Technical Preservation Services
Preservation Assistance Division
National Park Service
U.S. Department of the Interior
Washington, D.C.

Interpreting the Secretary of the Interior's Standards for Rehabilitation

Volume III

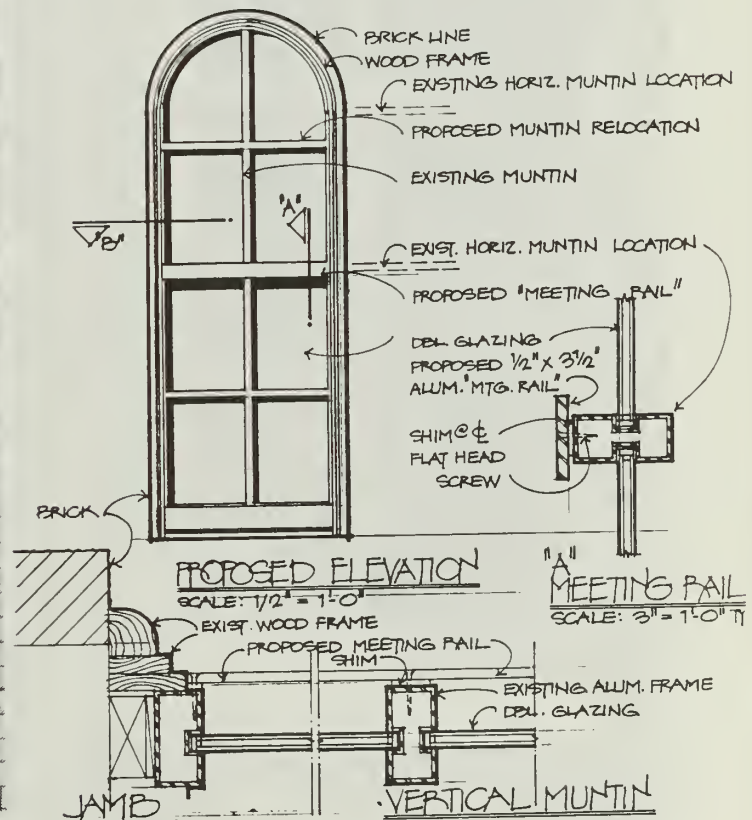
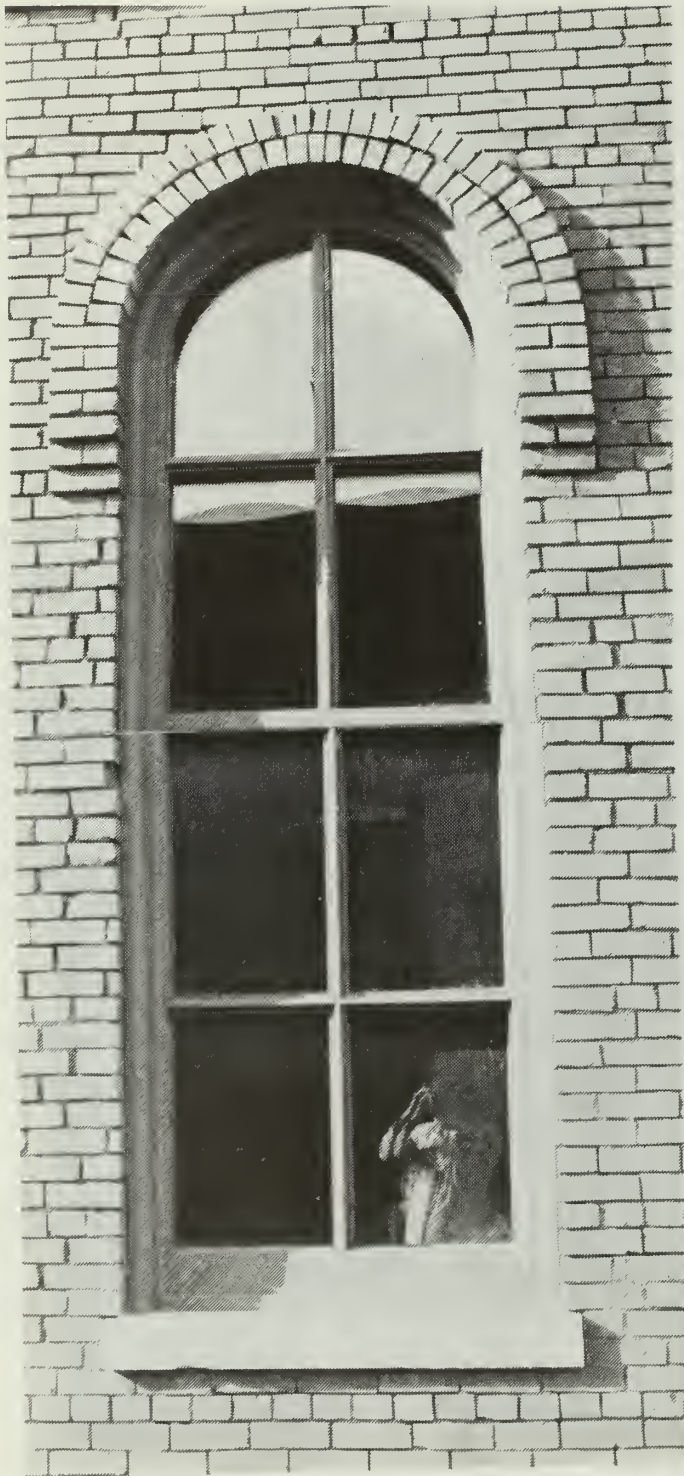
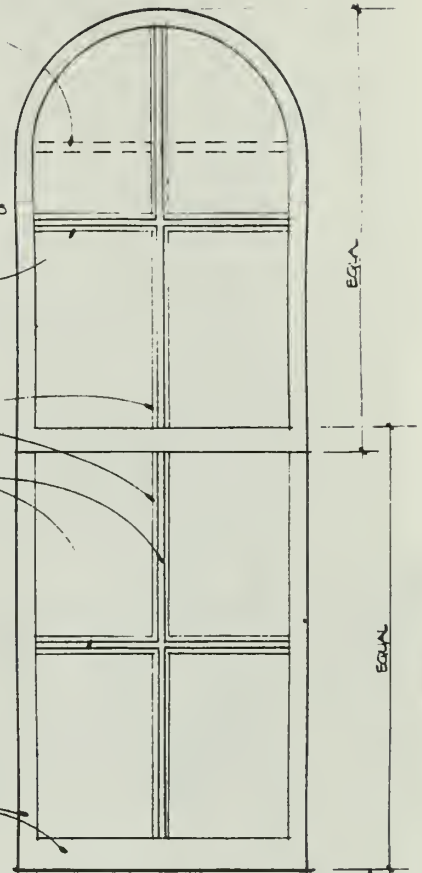
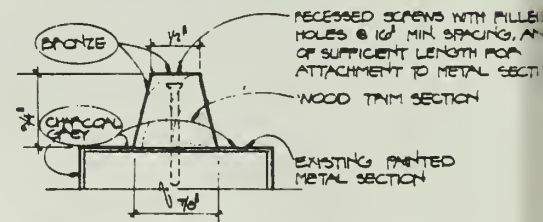
6. In an attempt to bring the inappropriate four-over-four replacement units (see 4 and 5.) into conformance with the Standards, two alternatives were proposed. In proposal A, the horizontal muntin at the top would be relocated so that all eight lights would be of equal size like the original. A 3 1/2" wide aluminum strip would be applied in an attempt to recapture some aspects of the meeting rail. Even after these adjustments, however, the upper and lower sash would read as a single, fixed unit; the muntins are also too wide and too flat.

7. In alternative B, proposed changes included installation of a wood brick molding. In an attempt to make the muntin appear thinner and visually recessed, the wide aluminum muntins would be painted a charcoal gray; trapezoidal shaped wood strips would also be applied to the existing flat muntin and painted to match the existing window color. Even making these modifications, the replacement window did not match the detailing of the historic window--the depth of the frame and muntin was still far too shallow, and the muntin profile and width was still inappropriate. This proposal was also rejected.

REMOVE TOP HORIZONTAL
MUNTIN & GLASS

APPLY WOOD TRIM SECTION
TO PAINTED MUNTINS

APPLY 3/4" THICK x FULL WIDTH
(OF EXISTING SECTION) WOOD
SECTIONS TO HORIZONTAL &
VERTICAL PERIMETER SECTIONS
& TO HORIZONTAL MEETING PAIR
COLOR TO BE BRONZE

4. Aluminum replacement window with a wood mock-up of an applied unglazed sash frame and muntin placed over the upper aluminum sash. The applied frame and muntin look like temporary add-ons, rather than matching the historic sash.

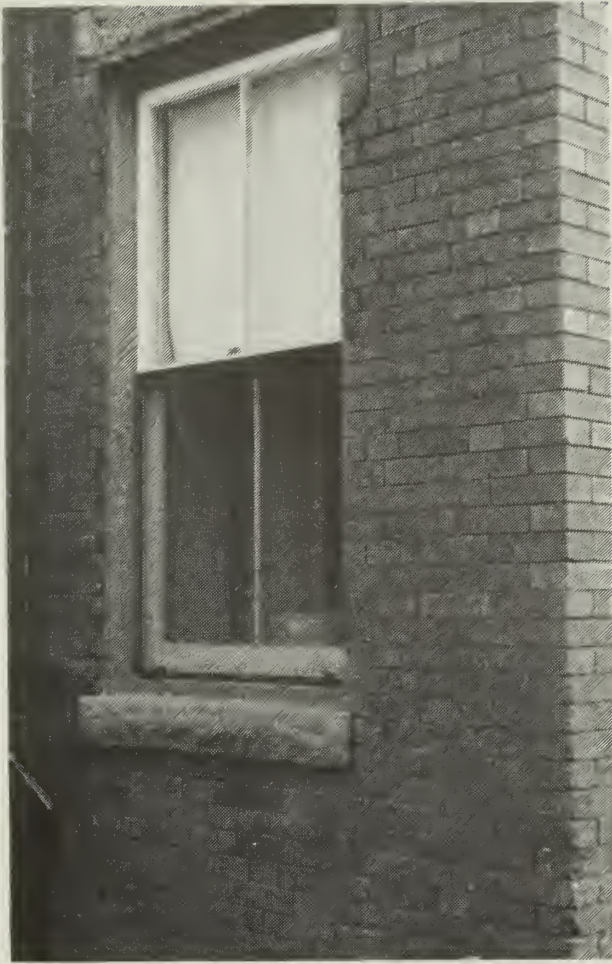
milled of wood and applied over the existing flush metal sections of the new aluminum windows (see illus. 4). However, it was determined that this modification did not capture the historic appearance of the existing wood windows. Wood frames fabricated with central dividing muntins and applied to each window would not faithfully duplicate the configuration of the old windows and would read as a temporary treatment, rather than an integral component of the sash. In view of the proximity and visibility of these windows to the street, any superficial or cosmetic change to the existing replacement sash, regardless of material, would not be consistent with the historic character of this building.

To bring this rehabilitation into conformance with the Standards, the owner decided to replace the new aluminum windows, which were clearly visible from the street, with new wood sash duplicating the originals in size, profile, muntin configuration, and composition (see illus. 5 and 6). With the new wooden sash in place, the project was subsequently certified.

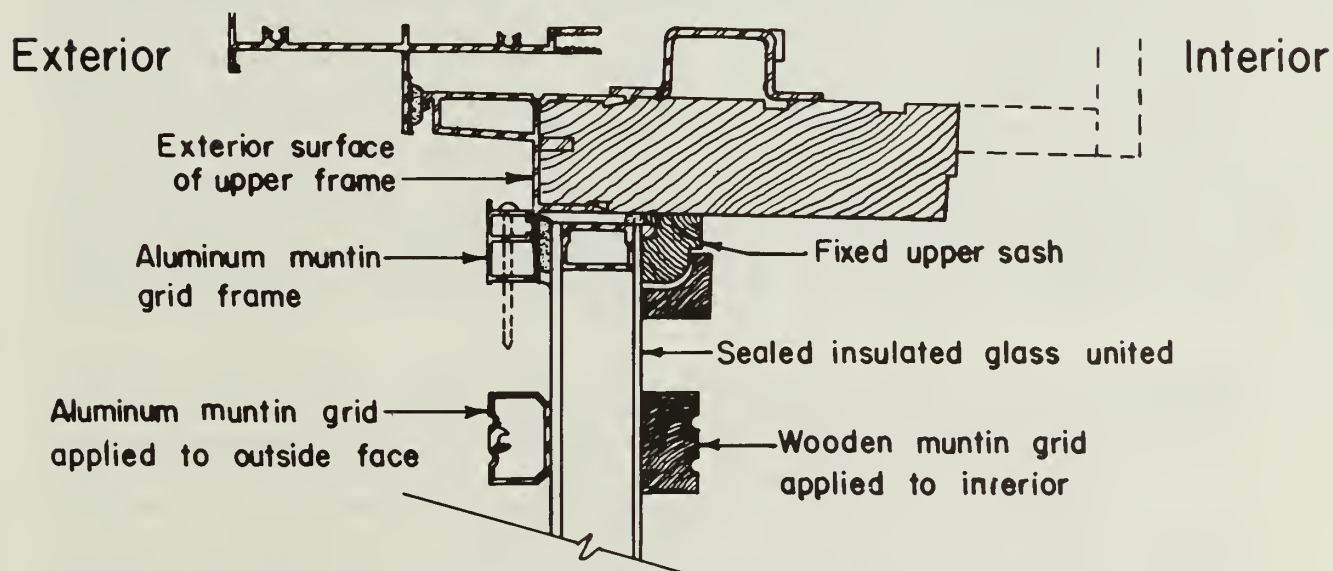
The replacement windows, however, did not adequately duplicate the visual qualities of the historic windows, specifically in appearance, shadow lines, muntin detail and planar qualities. In addition to the change from an arch-headed to a square-headed sash, a number of other distinct changes have occurred to the historic appearance of these windows. The double-hung, historic wood windows have been replaced by fixed metal units with much narrower sash dimensions, noticeably changing the planar relationship of the upper and lower sash. The resultant effect is that at certain angles the replacement windows have the appearance of the upper and lower sash being in the same plane, rather than duplicating the appearance of the historic, double-hung sash (see illus. 3-5).

The thickness of the meeting rail so evident in the historic sash has been reduced in depth creating a weaker shadow line (see illus. 5). The use of an applied aluminum muntin grid rather than true 16-over-16 wood muntin divisions has caused significant changes to the appearance of the windows (see illus. 6). The muntin grid clearly does not match the original, since the new muntins have a rectangular rather than trapezoidal profile, it has a ribbed surface, and it extends beyond the plane of the rails and stiles. The projecting grid, furthermore, creates additional shadow lines that did not exist on the historic windows. The historic muntins were flush to the surface of the sash, integral to the sash frame construction and trapezoidal in shape after puttying.

8. Proposed replacement windows on third floor and original windows below. Note how dark sash and frames are unobtrusive, light sash and frames create a striking pattern on the red brick facade.

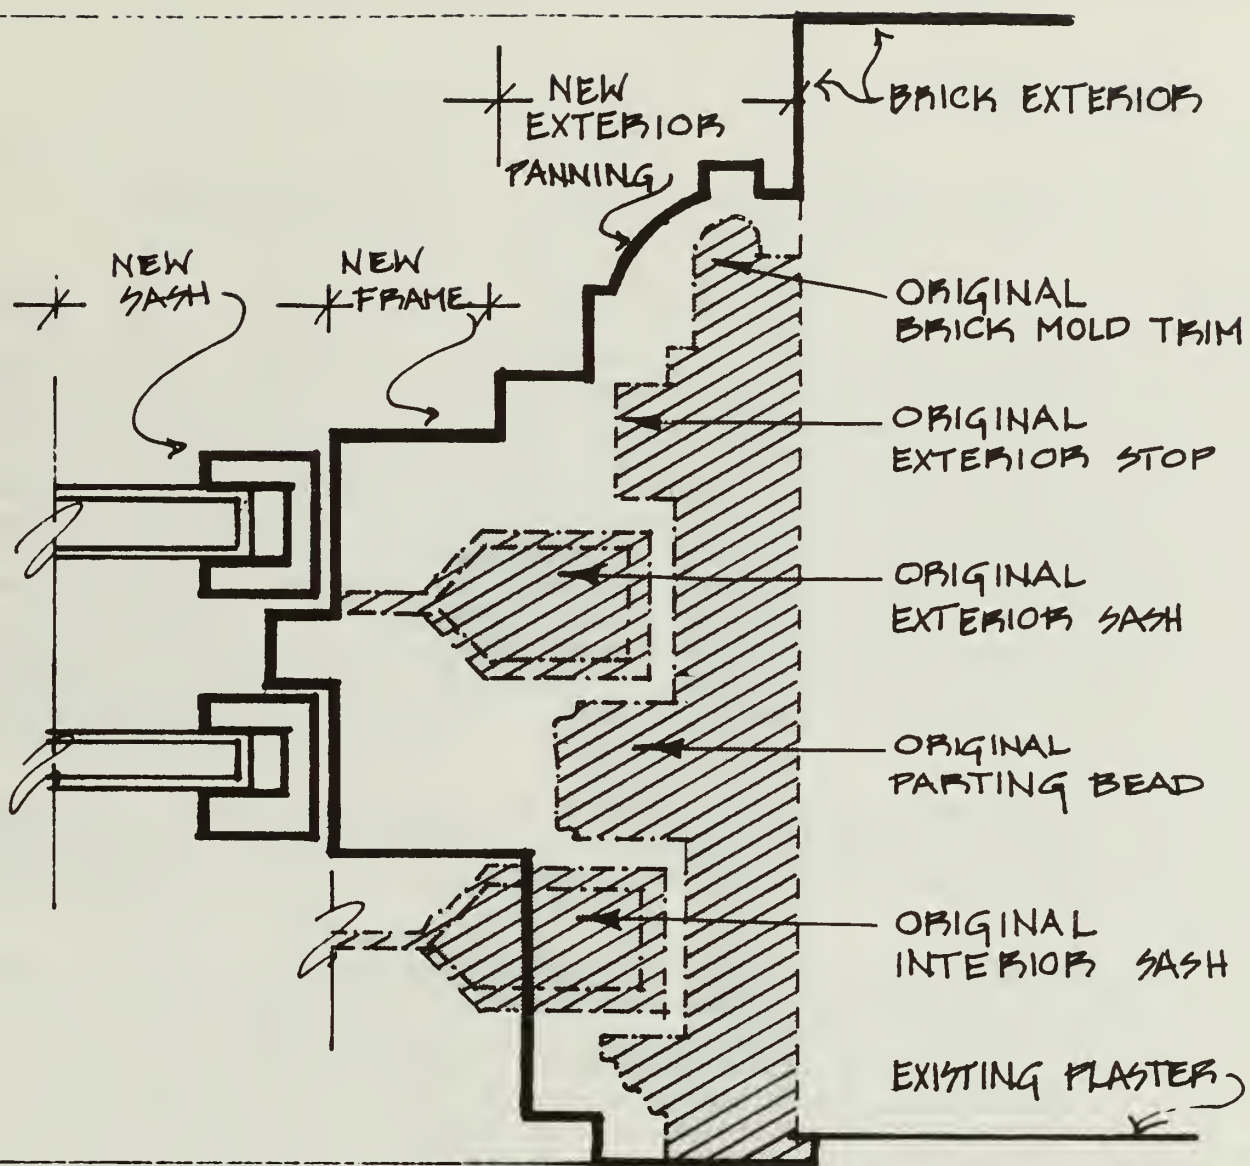
Aluminum, double-hung windows with attached metal grids on the exterior and interior to simulate muntins were chosen to replace the originals (see illus. 6-7). Several of these windows were installed to evaluate their effectiveness in matching the adjacent historic windows. These windows were, however, determined not to adequately duplicate the visual qualities of the historic windows in their color, proportion, size, and installation detail of the originals. A light ivory color was chosen, rather than the dark green of the historic sash, causing the windows to stand out against the facade rather than to recede as the dark-colored historic sash had done (see illus. 8). The new

9. Drawing of proposed window and original window and frame location. Note how new sash and frame are set closer to the exterior and within the window opening. The owner's alternative panning identified above will not correct the deficiencies of the sash.

2. The plan shows room size and arrangement; units converted to two-story spaces by cutting through the first floor are denoted by shadowing.

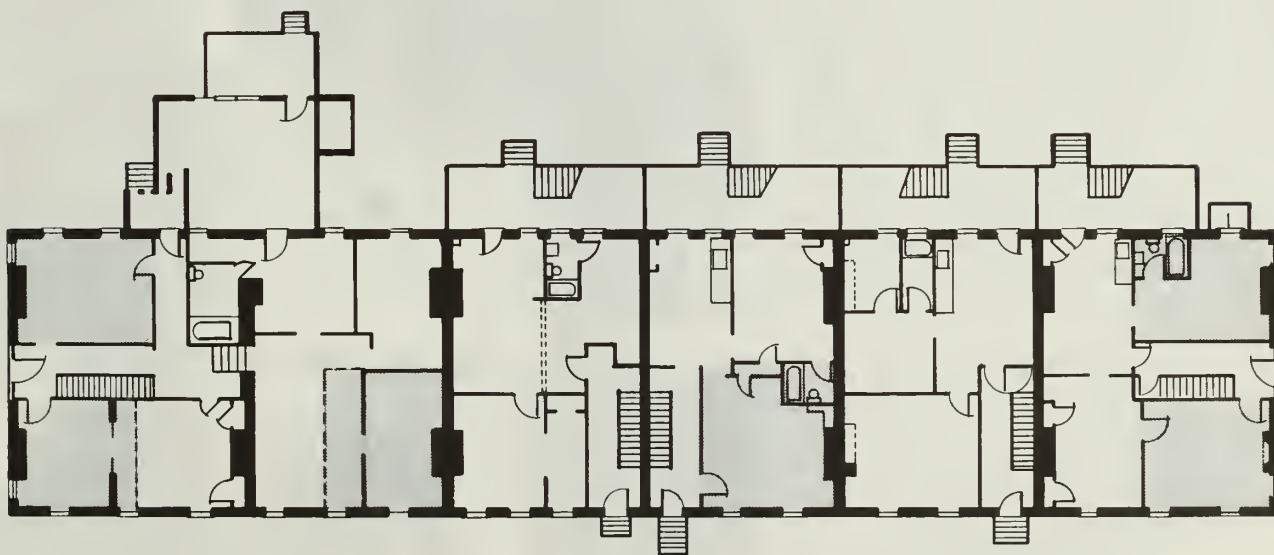
The rehabilitation was determined not to meet the Standards owing to the removal of large portions of the first floor in order to create two-story spaces that would permit additional light to rooms newly inserted in the basement. The change radically altered the historic spatial definition of these rooms as well altering the historic relationship of the first and primary floors to other floors in the buildings. This work was totally incongruous with the simple, but distinct historic character of the 19th century residential structures. In a denial letter to the owner, NPS explained further that the continued residential use of these buildings should not have posed any major problem or need for extensive changes to the building's overall historic design:

Furthermore, the design character of the new space is incompatible with the vernacular character of the building, thus violating Standard 9.

An alternative to removing portions of the floor would have been to regrade at the rear to permit more light to enter the basement through enlarged windows. It was further noted by NPS that the incompatible spatial changes were all the more regrettable because they were not essential to a viable reuse scheme for the buildings or to extending their useful life.

4. Site plan after relocation of buildings. The neighboring house was moved and turned around (B2) to face the 1900 building (A) across a paved parking lot. The cottage associated with the moved house was relocated (C2) behind the 1900 building.

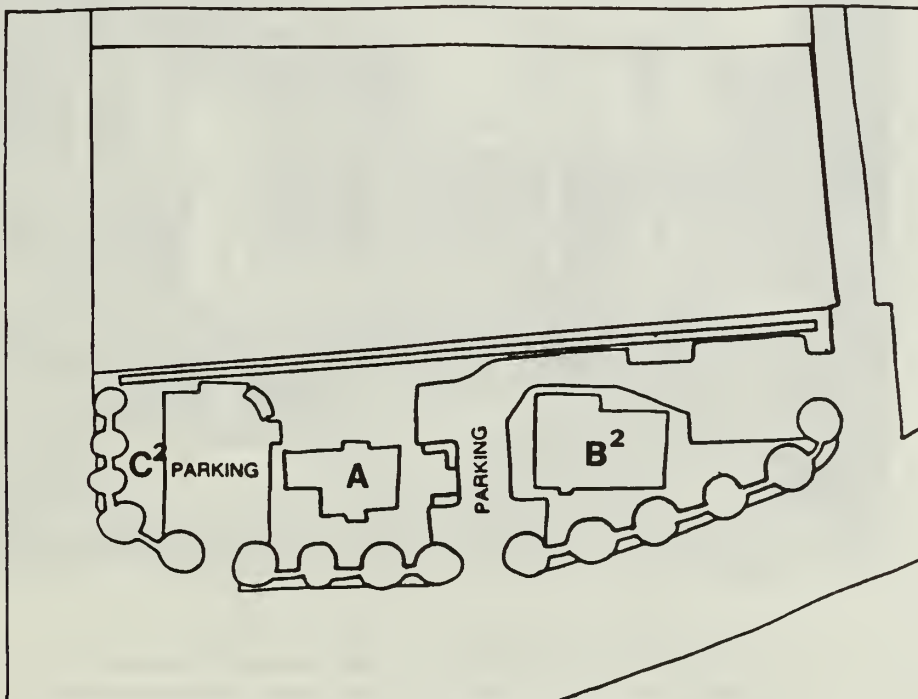
Although both of the moved buildings were saved from demolition, their relocation in the manner shown here has nearly obliterated the historic setting of the 1900 building. That building appears as a subordinate element in a new composition bearing little relationship to the historic appearance of the property. The central parking lot, furthermore, has become the dominant feature of the site (see illus. 6). The project does not meet the Standards for Rehabilitation.

3. New stair after rehabilitation. Design of stair was not based on historic evidence.

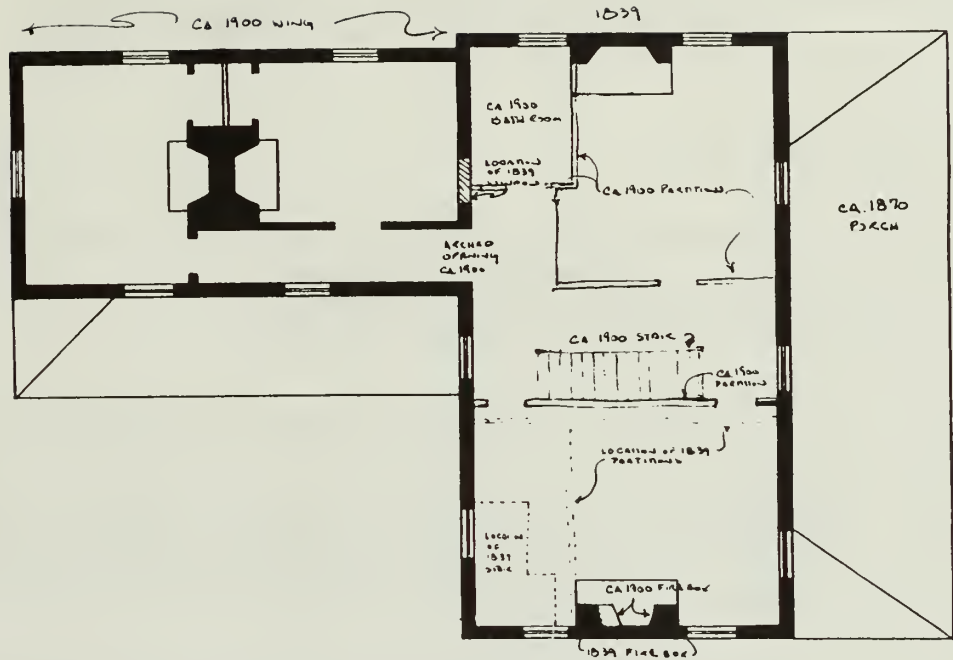
1839 and 1870. The ca. 1870 porch, however, was retained and preserved, as was the ca. 1912 rear ell addition. Although the new stair was based on scattered ghost marks and fragments of the original stair, there was no evidence of what the original bannister and newel post looked like, and as a result the new appearance is conjectural (see illus. 3). Also conjectural is the design of the new front door which was installed to replace two ca. 1912 doors. The only evidence existing for the front door was three hinges found near the suspected location of the original door.

Selective restoration in this rehabilitation would have been appropriate if the entire 1839-1870 main block of the building, the significant academy structure, had been restored, with the rear ell addition (ca. 1912) being retained and preserved as a representative example of the building's change of use. If evidence did not exist to accurately restore the building to its academy period, retention and preservation of the entire structure as a twentieth century residence would have been acceptable.
